BUILDING COMPLETION REPORT.

AMMENDED PLAN OF PROPOSED BUILDING ON

PLOT NO 71 SHEET NO JL 6

JAIL QUARTER

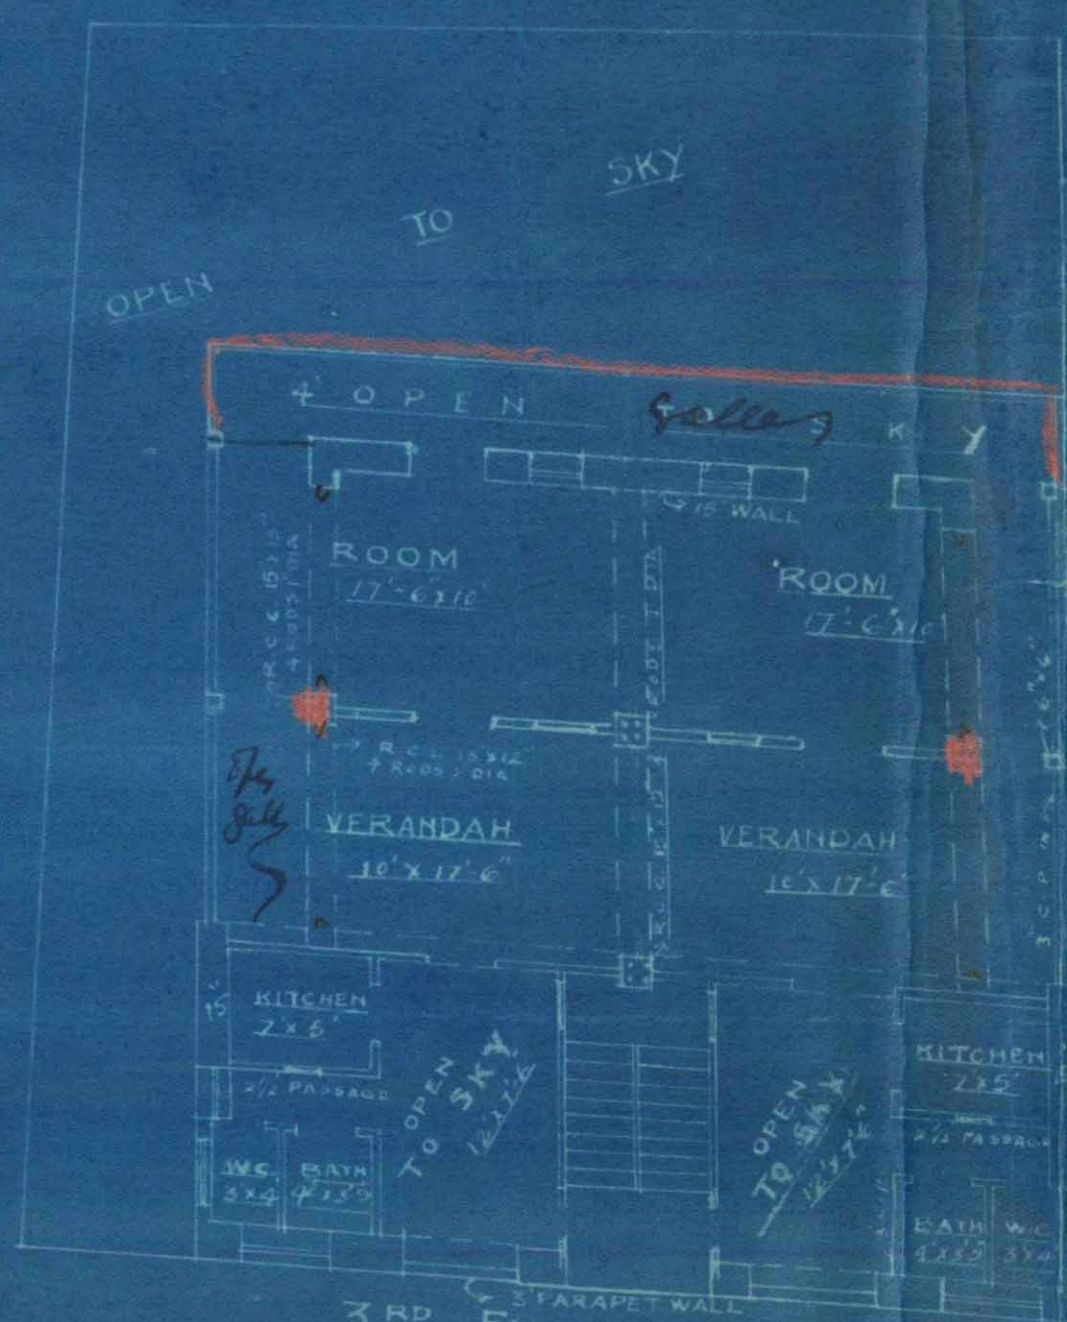
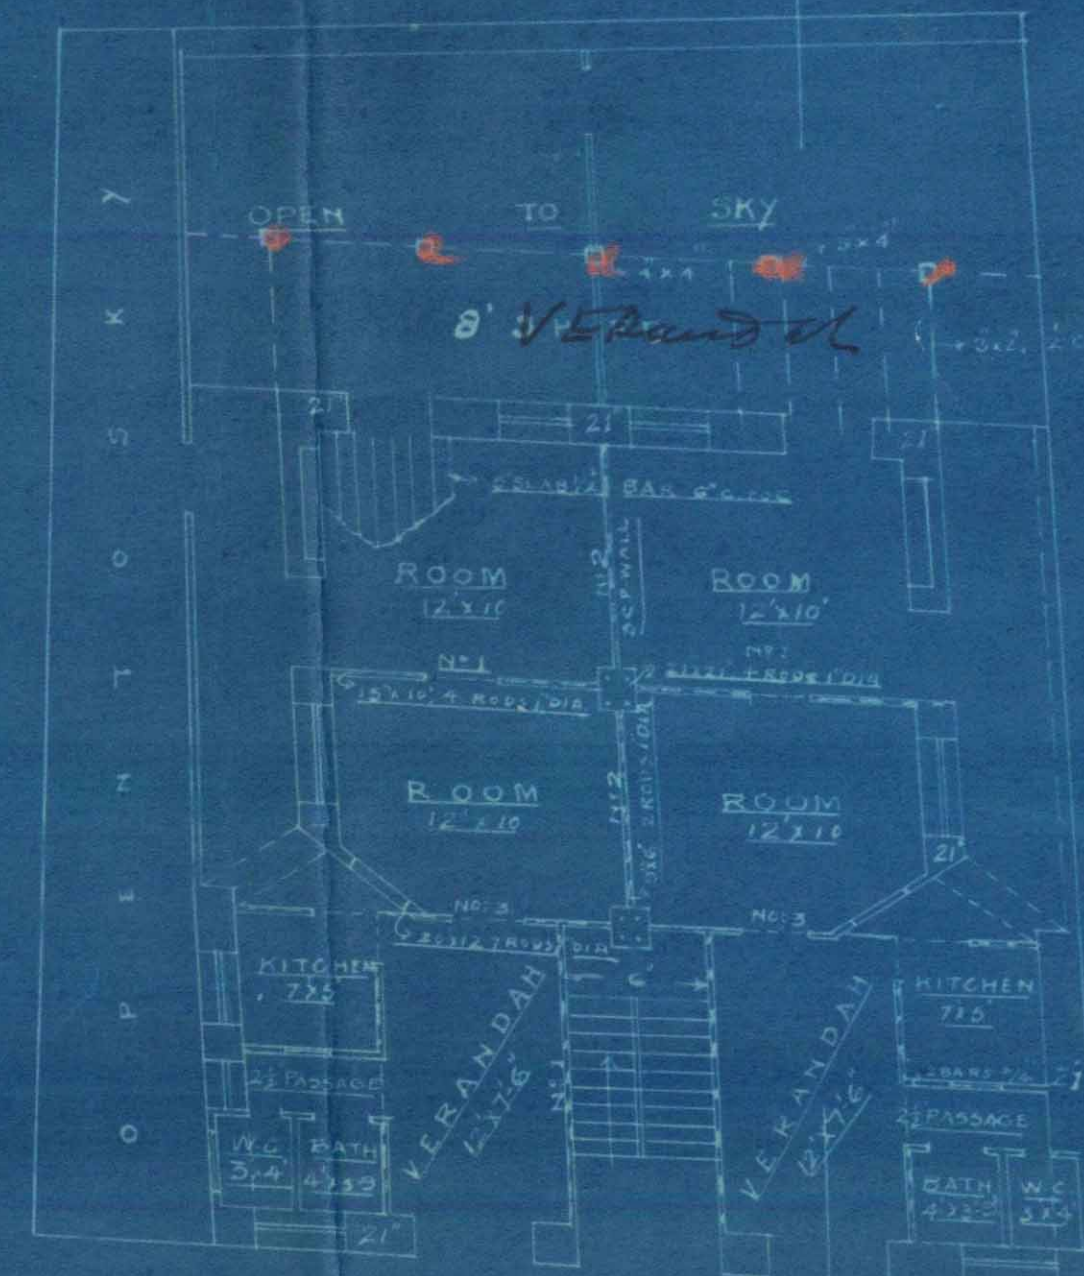
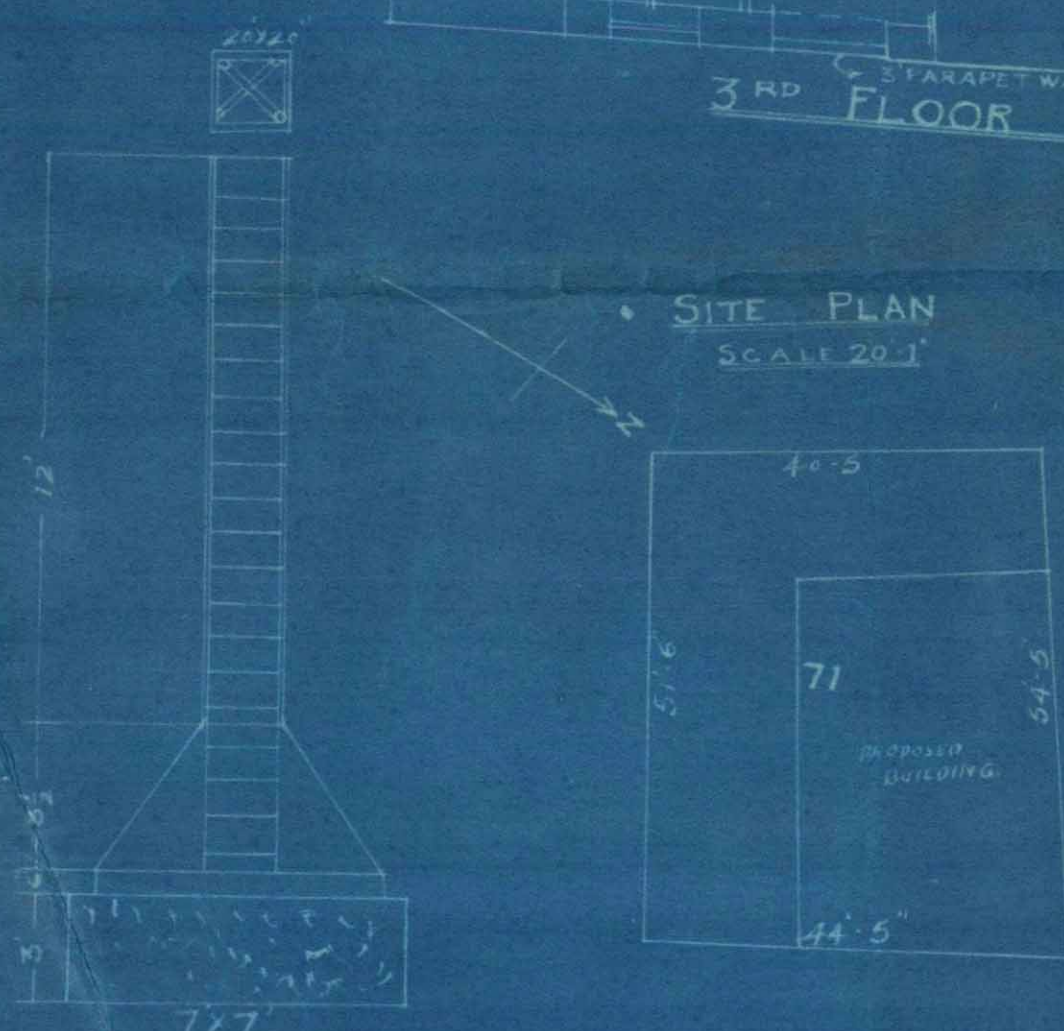
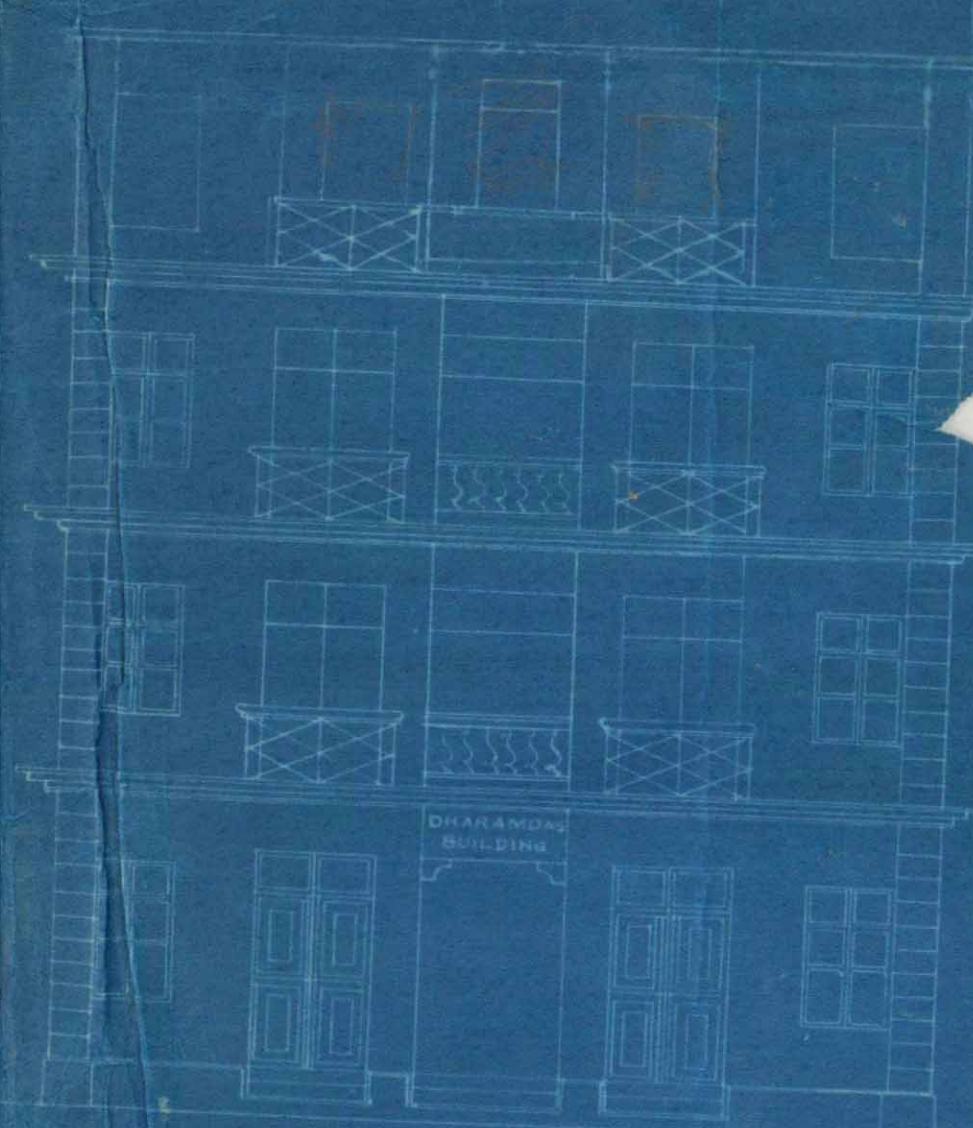
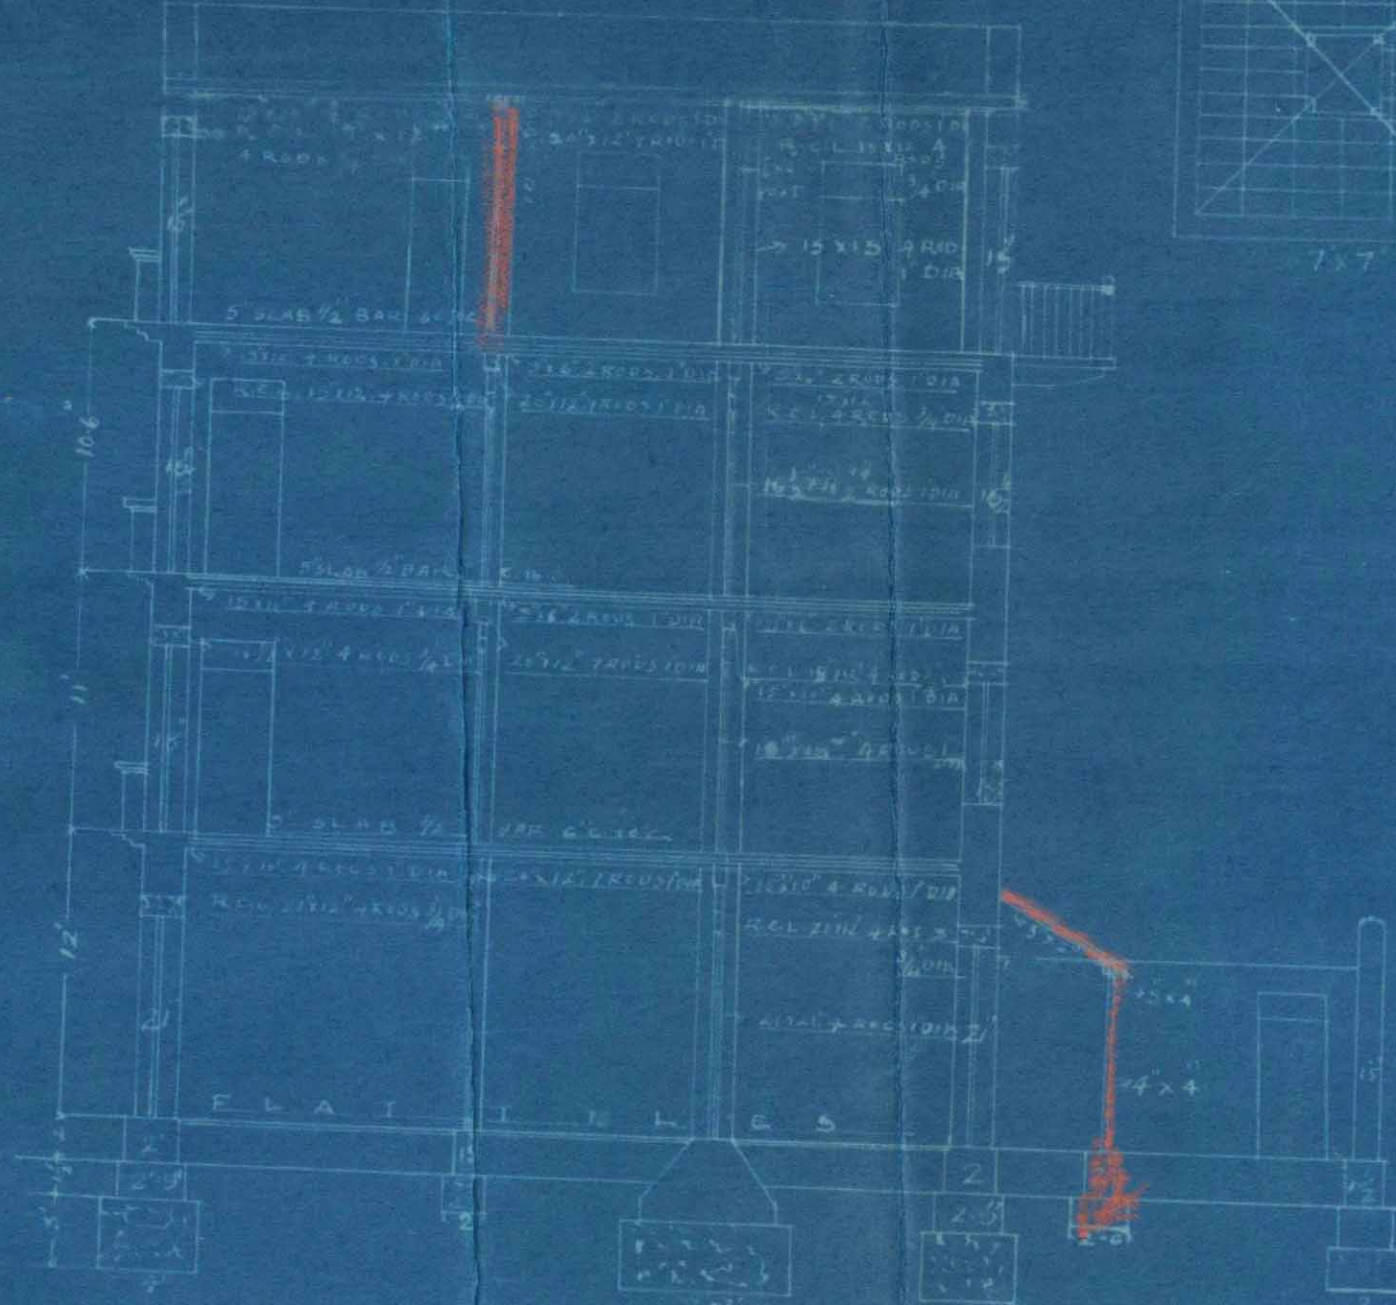
- (1) Structures lighter than already passed in the Sanctioned
- (2) plans cannot be allowed. As one goes up one should
- (3) leave more open space and not throw verandah
- (4) galleries etc into rooms, nominally called verandahs
- (5) in the plans submitted
- (6)
- (7)
- (8)
- (9)

*Inform him that Shukla's light
than already passed in his hands
He cannot be allowed. As one goes
up he should leave more open & not
throw Veranda pillars & into
rooms dominantly called Veranda
in the Plans submitted.*

I beg to resubmit herewith the plans duly amended
as desired.

*Rev. Secy.**Amended**1/3/29**Plans may be approved**1/3/29*
